NEW SUMMARY OF SUBMISSIONS Byford District Structure Plan PA18/777

Advertising Date: 21 May 2020 to 31 August 2020

FIGURE 3: DRAFT LPS 3 ZONING MAP

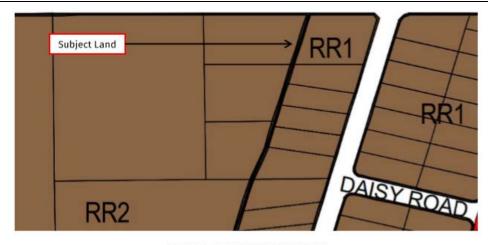
Submitter	No	Submitter Comments	Officer Comment	Officer
				Recommendation
	· · · · · · · · · · · · · · · · · · ·			
		creation of a balance lot with separate frontage to Cardup Siding Road. The draft Byford DSP recognises (to an extent) the special circumstances that apply to this precinct by designating lots on the west side of Alice Road as 'Special Residential' (See Figure 2 below).	t	
		Subject Land Su		
		FIGURE 1: AERIAL LOCALITY PLAN		
		The subject land is currently zoned 'Rural' under the Shire of Serpentine- Jarrahdale Town Planning Scheme No.2. (TPS 2). Under Draft Local Planning Scheme No.3 (LPS 3), the eastern portion of the subject land is proposed to be zoned 'Rural Residential 1' and the western portion 'Rural Residential 2' (See Figure 3 below.

Neither the current TPS 2, nor draft LPS 3 properly recognise the established pattern of subdivision within this precinct and provide for the logical completion of subdivision and development as anticipated by landowners who have held land for a significant period of time with the very reasonable expectation that the subdivision potential of the land could be realised.
